ADDENDUM
NO. 3

April 17, 2026

**TRI-TOWNSHIP WANATAH SCHOOL
RENOVATION AND RELATED WORK
Wanatah, IN 46390**

This Addendum consists of Pages ADD 3-1 through ADD 3-4, and attached Addendum No. 3 from Gibraltar Design dated April 16, 2026 and consisting of 5 pages, replacement Specification Section 33 40 00 - Storm Sewage Systems, and 15 drawings.

© GIBRALTAR DESIGN SHEET
A-201

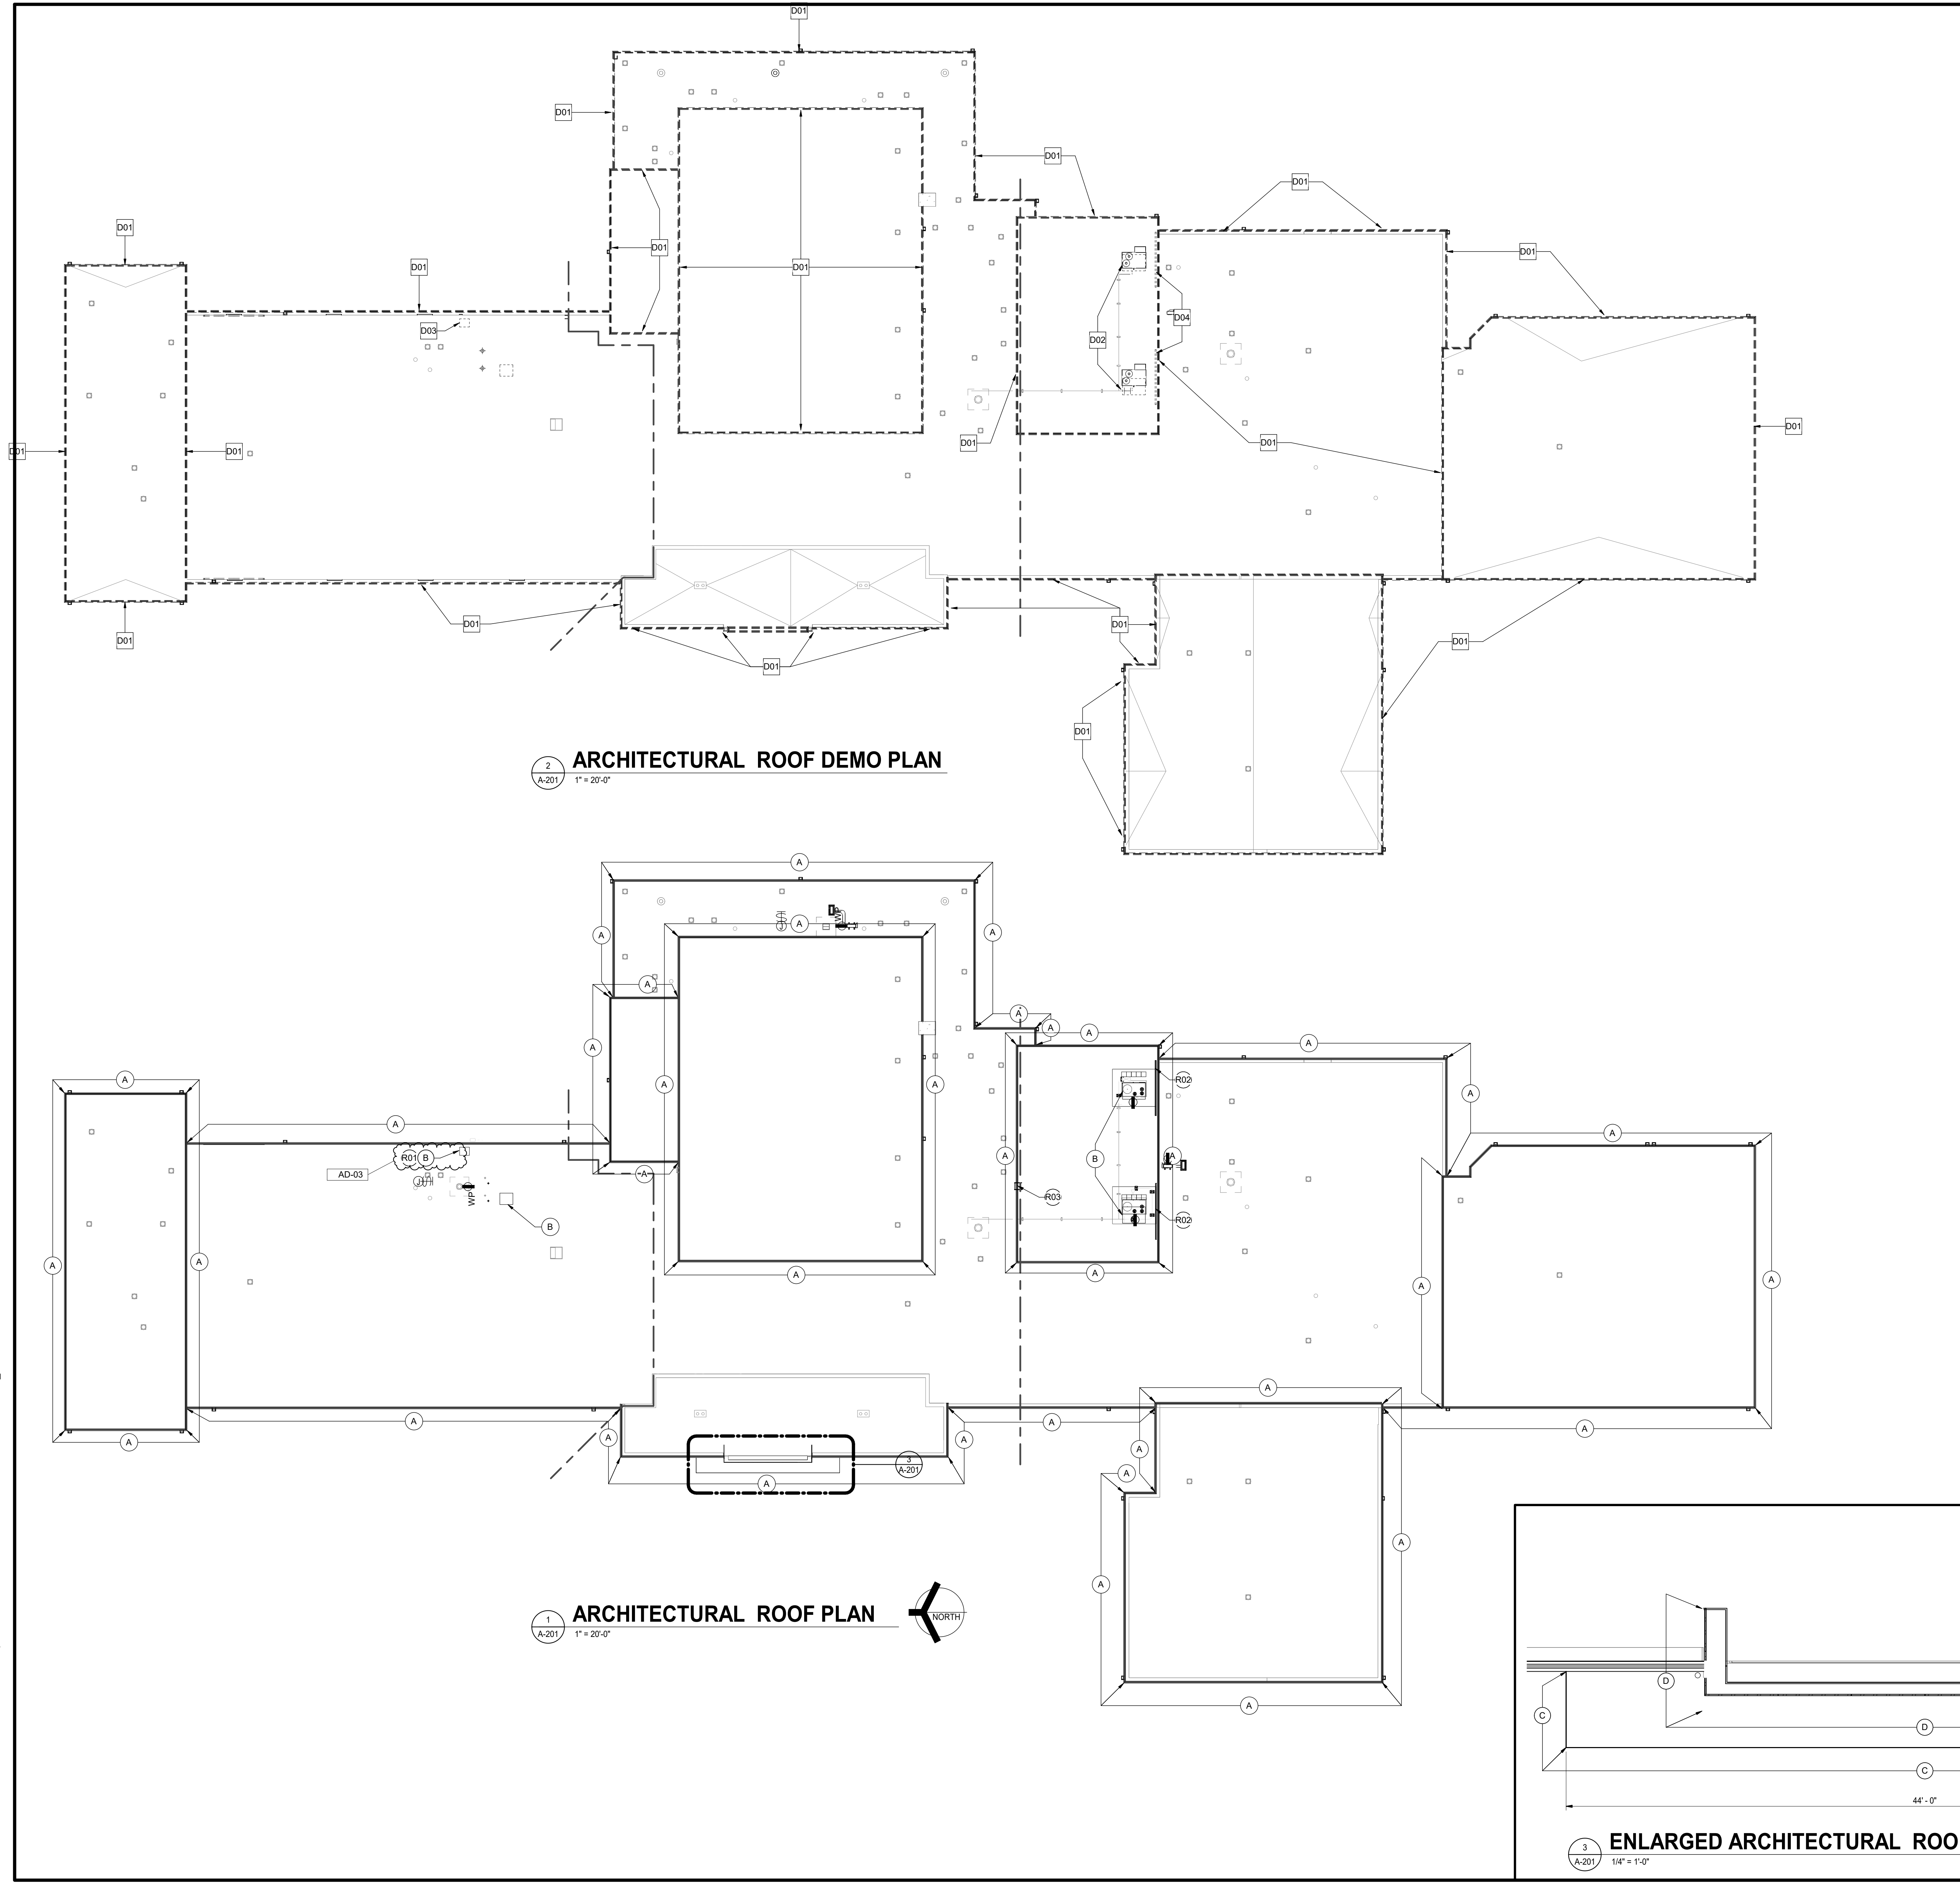
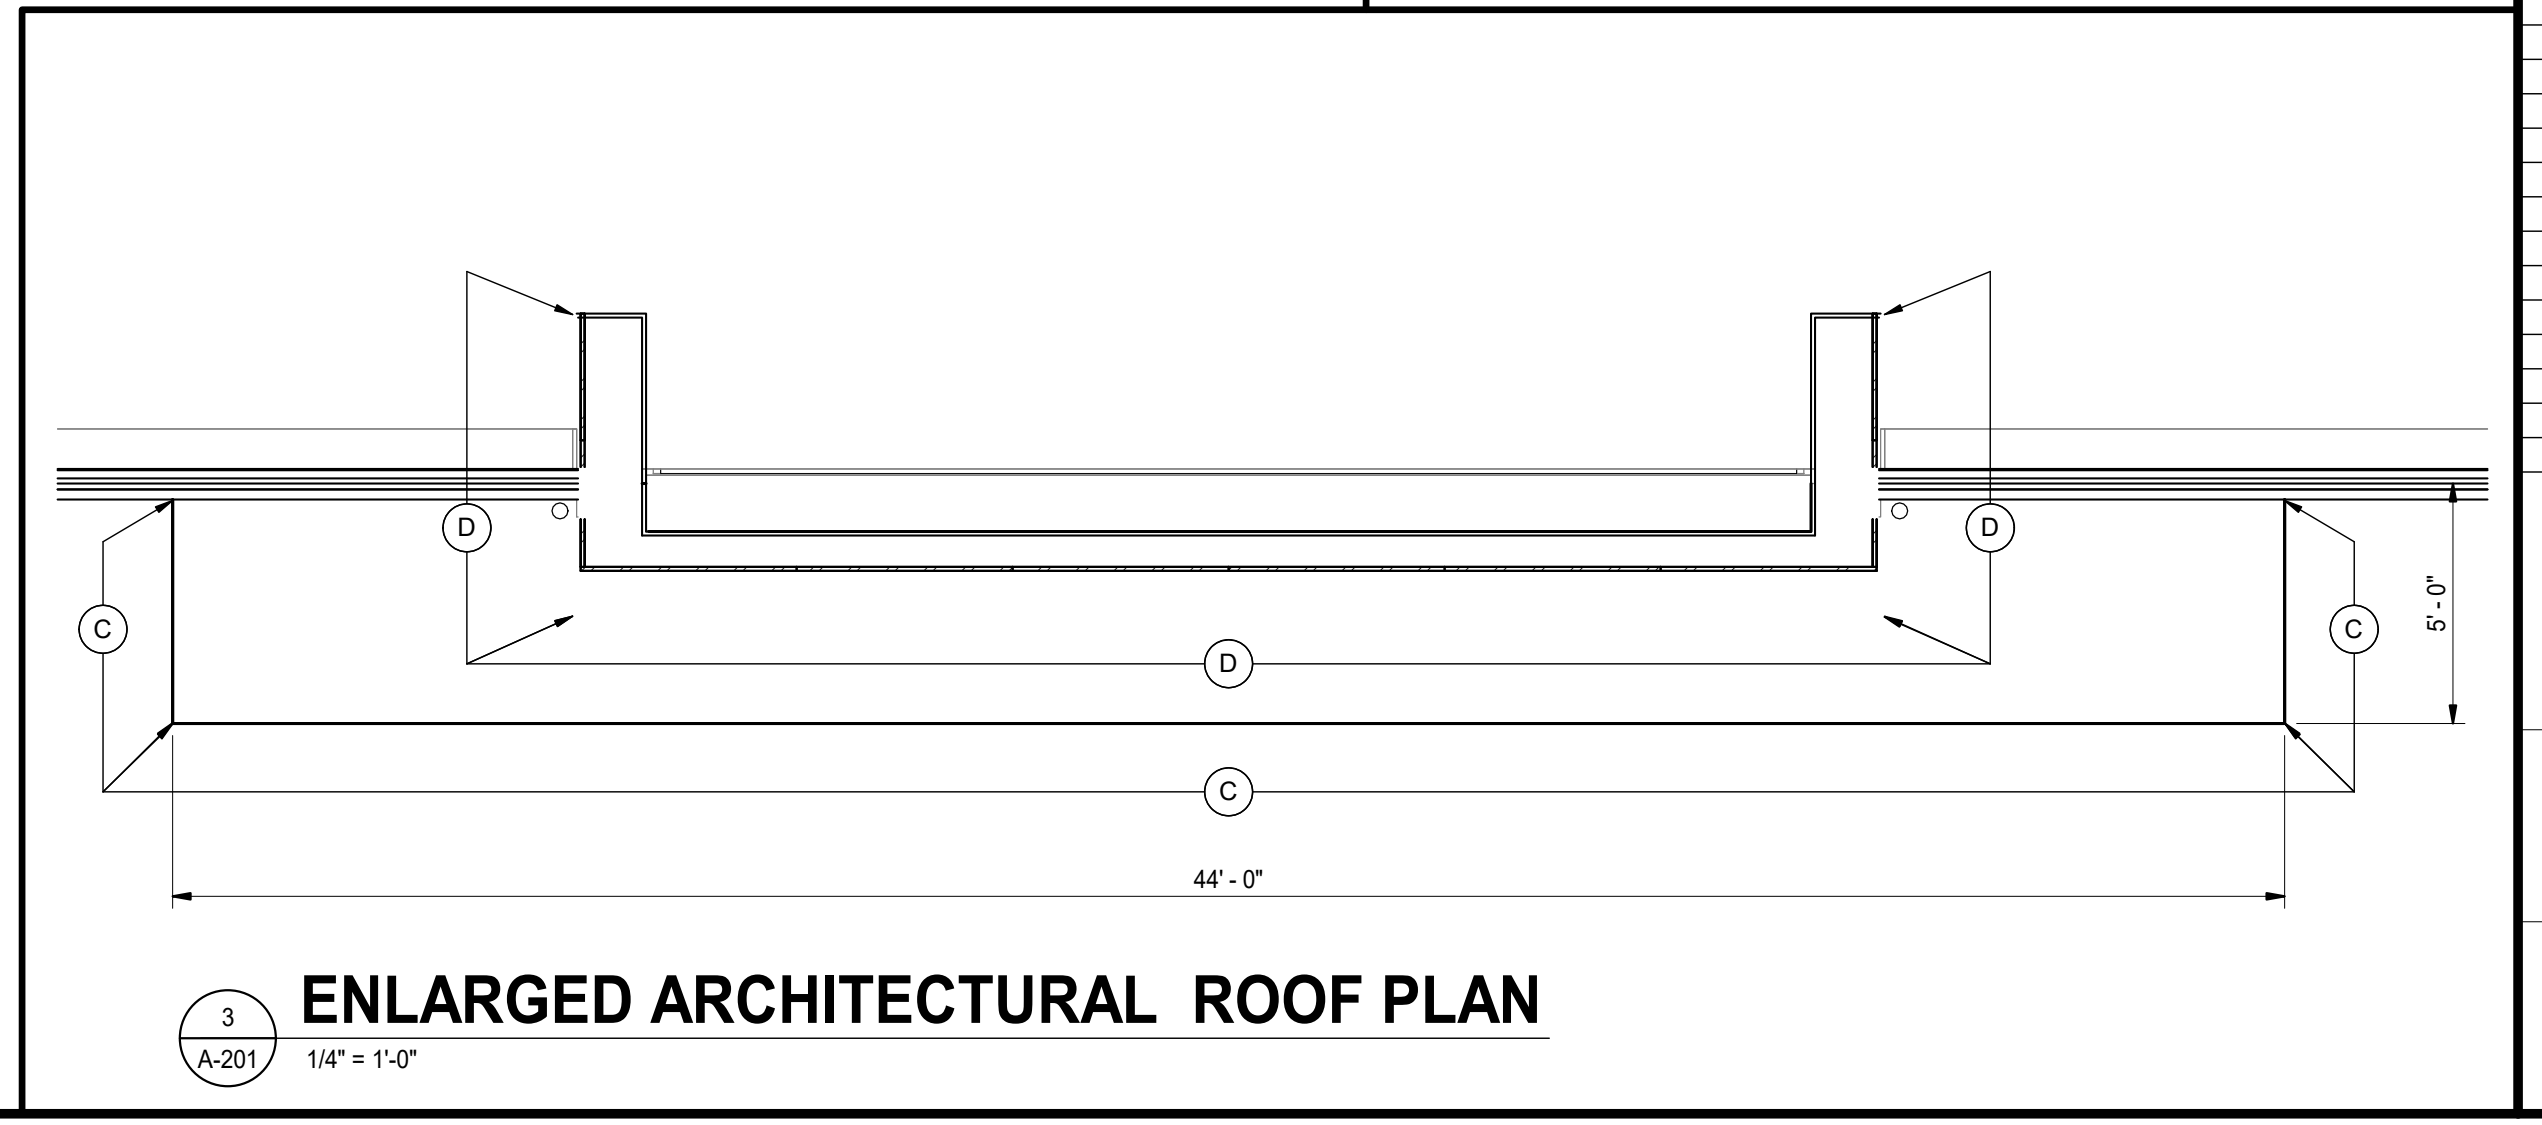
19. Sheet A-201

- A. Refer to revised, full-size drawing, for Roof Plan Note clarifications, included in this Addendum.
